**Amendments to the Drawings:**

Title: SYSTEM AND METHOD OF CONTROLLING V-BELT TYPE CONTINUOUSLY VARIABLE TRANSMISSION

Inventor(s): Masahiro YAMAMOTO et al.  
Appl. No.: 10/674,818

FIG.2

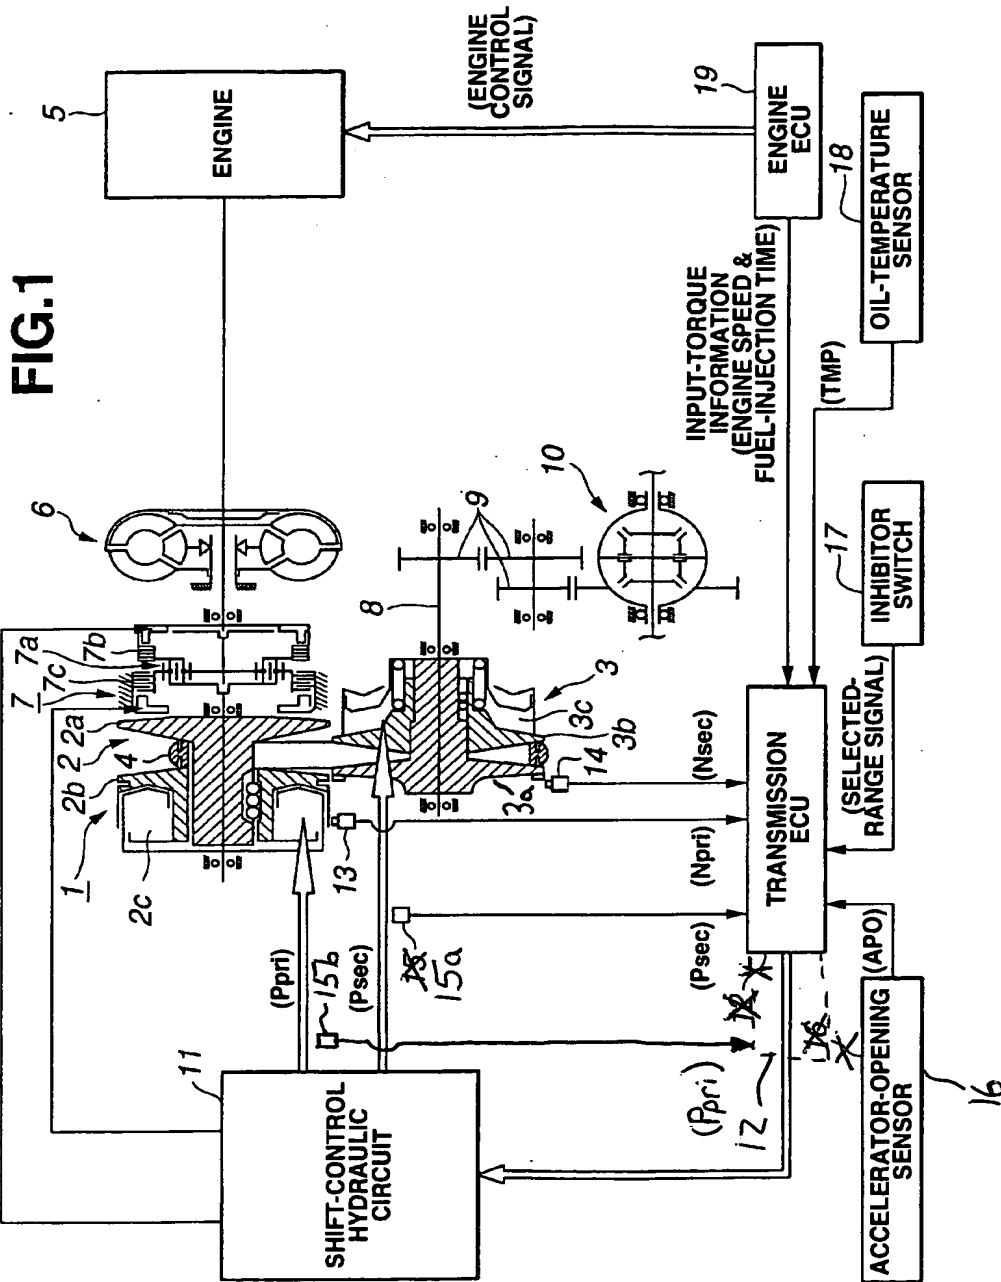
The specific change which has been made to Figure 2, is "15" has been changed to "15a."

FIG.4

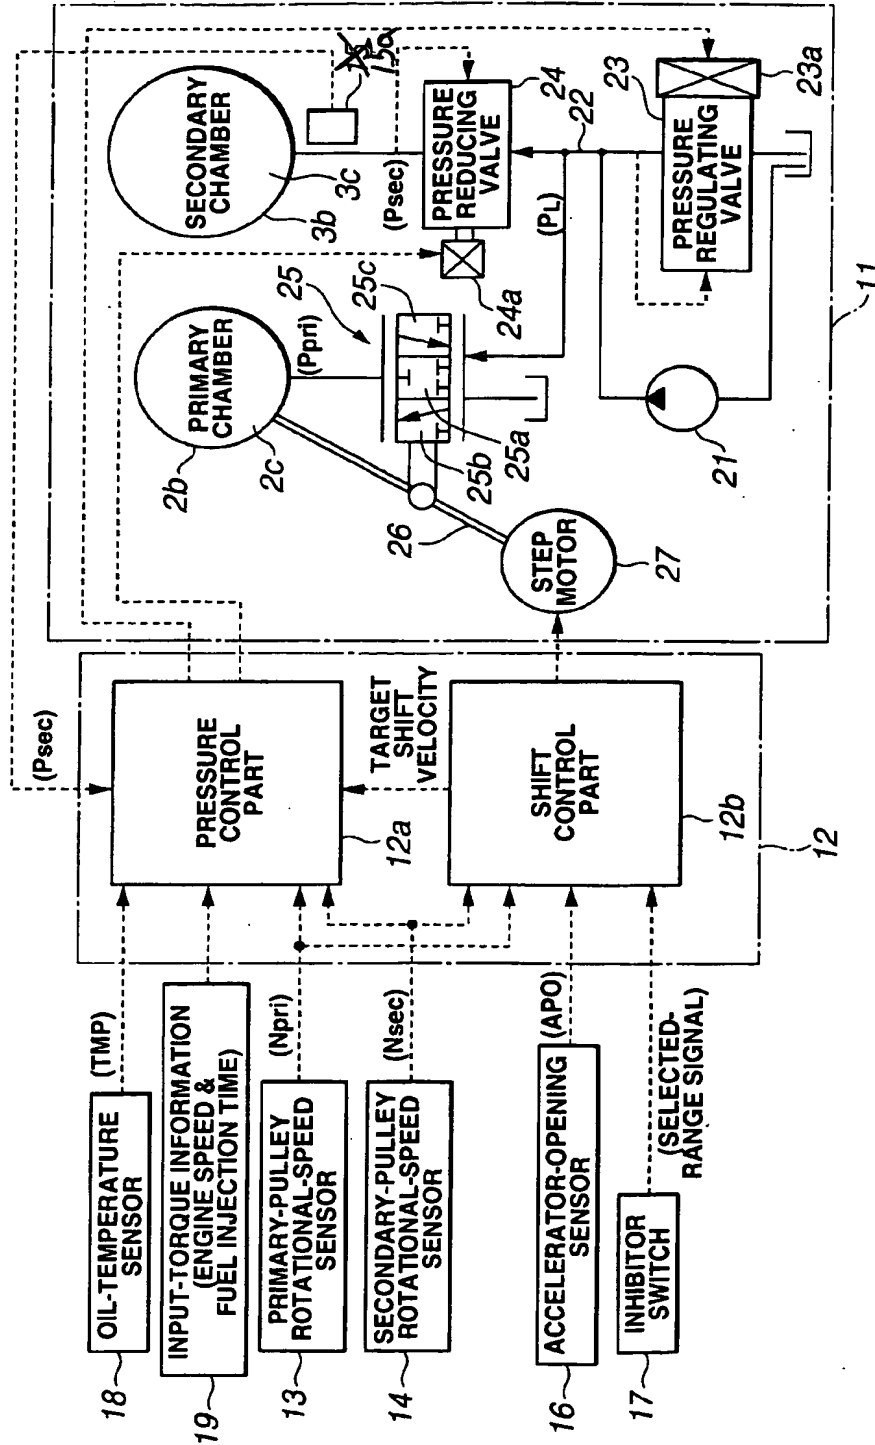
The specific change, which has been made to Figure 4, is "HIGT" has been changed to "HIGH."
